SERVICE LETTER

No. 532

Piper Aircraft Corporation

Subject: Voltage Regulation Component Grounding

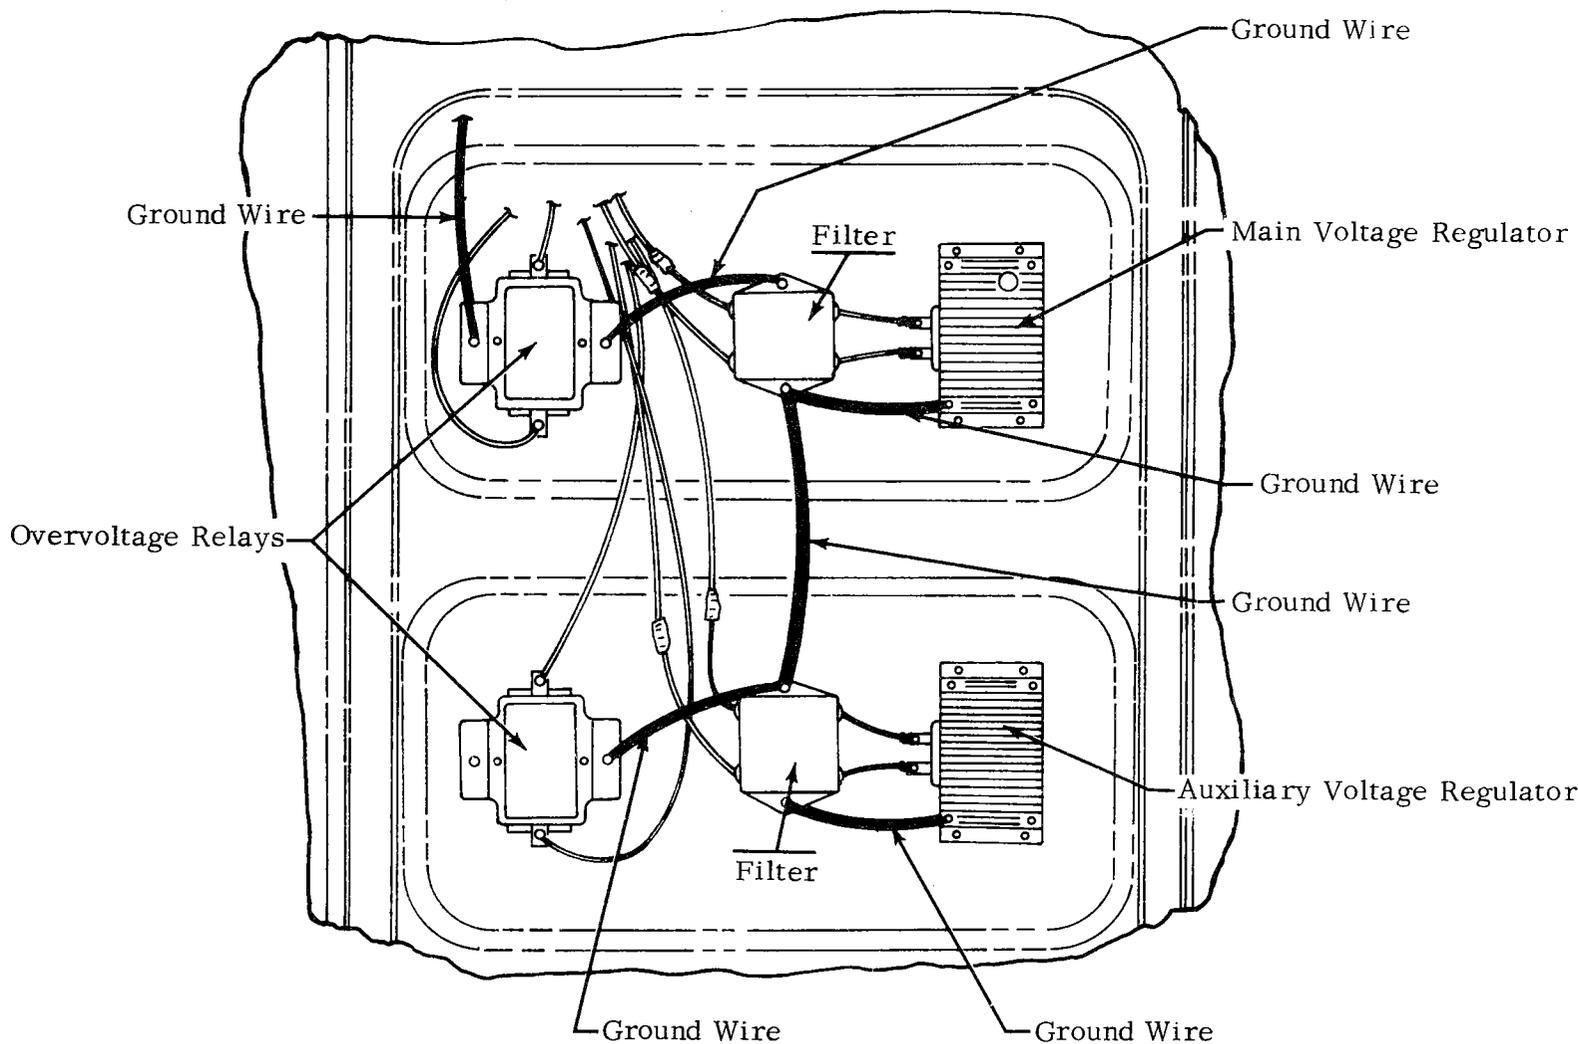
Purpose: To provide a supplemental method of grounding the aircraft voltage regulation system components to the aircraft structure. See sketch attached to this letter for general information.

This Sketch represents the Aztec "D" Voltage Regulation Component Grounding Modification, and is similar to the modification required for affected PA-30 and PA-31 aircraft.

Instructions: Contained in Kits No. 760 331 (PA-23-250 six place Aztec "D"), 760 332 (PA-30 Twin Comanche "C") and 760 333 (PA-31 and PA-31-300 Navajo) Voltage Regulation Component Grounding Installation
